Peer Panel on Waste Package Materials Performance

Presentation of the Final Report

Localized Corrosion

U.S. Department of Energy (DOE)

Localized Corrosion - Project Approach

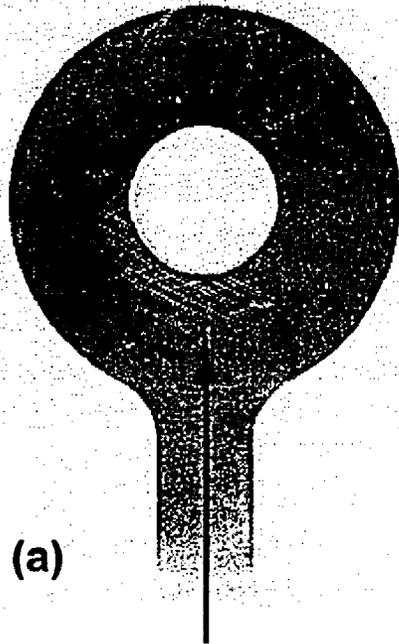
- Problems with Project approach:
 - Samples used in potentiodynamic experiments were nominally **uncreviced**.
 - **Alloys do not exhibit localized corrosion in tested environments – E_{crit} is not related to localized corrosion.** In other words, the model for localized corrosion is based on data that are unrelated to localized corrosion.
 - Does not allow extrapolation to other environments in which localized corrosion is possible.
 - E_{corr} values (zero current potentials in polarization curves) are **not indicative of long term corrosion potential**.

1. The ΔE design criterion is appropriate and conservative if applied properly. The Project should take a more rigorous approach to the determination of the critical potentials:
 - The Project should use $E_{r,crev}$ from intentionally creviced samples that have undergone sufficient attack as the value of E_{crit} .
 - The Project should measure and model E_{corr} separately.
2. The Project should test under aggressive conditions in which the alloys are susceptible to localized corrosion. Extrapolation of E_{crit} and E_{corr} to any environment of interest would then be possible.

Localized Corrosion - Ennoblement

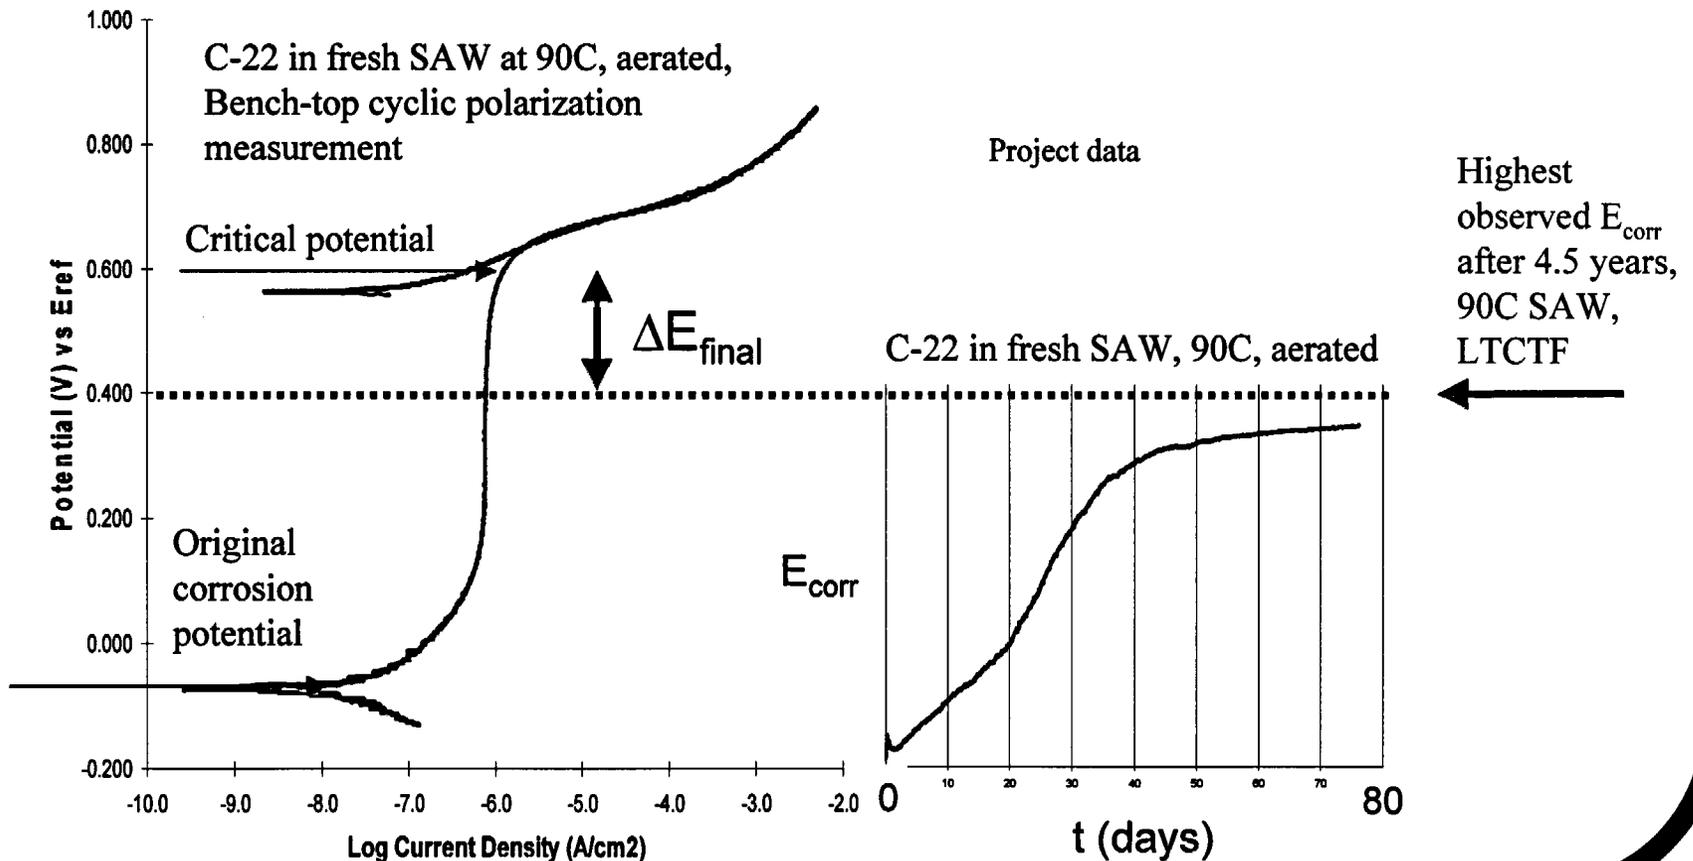
The project has measured E_{corr} to have increased by about 500 mV after 4.5 years in various solutions in the Long Term Corrosion Test Facility.

No localized corrosion was found, and the potential remained below the transpassive potential and close to the potential for Pt in that solution.

Localized Corrosion - Ennoblement

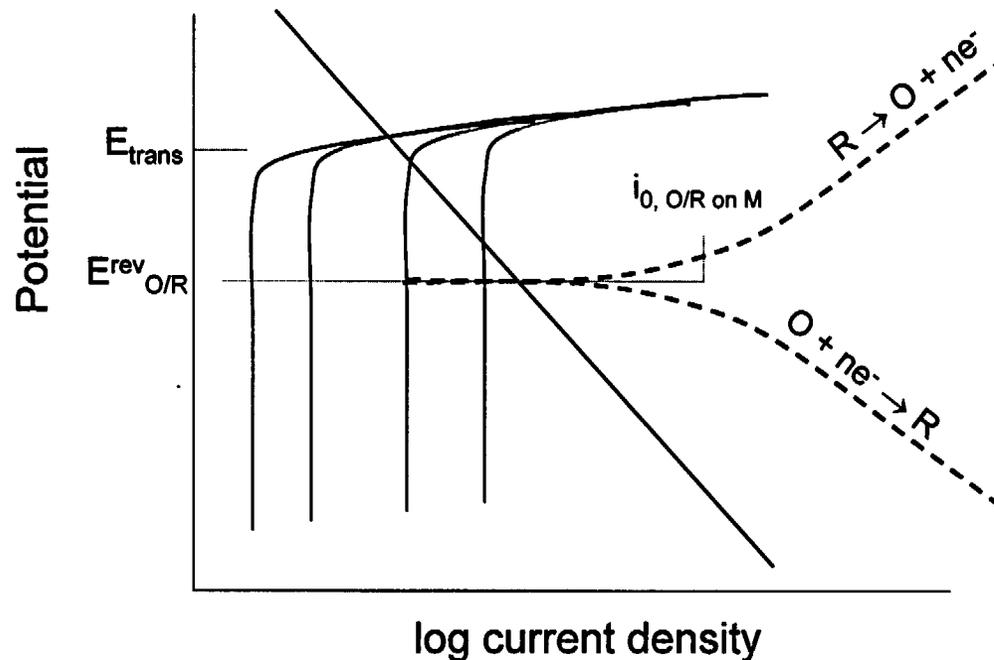
The corrosion potential might be pinned at a value below a critical potential if the solution contains a redox reaction with an exchange current density that becomes large relative to the passive current density as the passive current density decreases. Based on the potential of Pt, this seems to be happening over long times in SAW.

ΔE might get small with time, but that is not bad if E_{corr} stays below a conservative E_{crit} , such as $E_{\text{r,crev}}$.
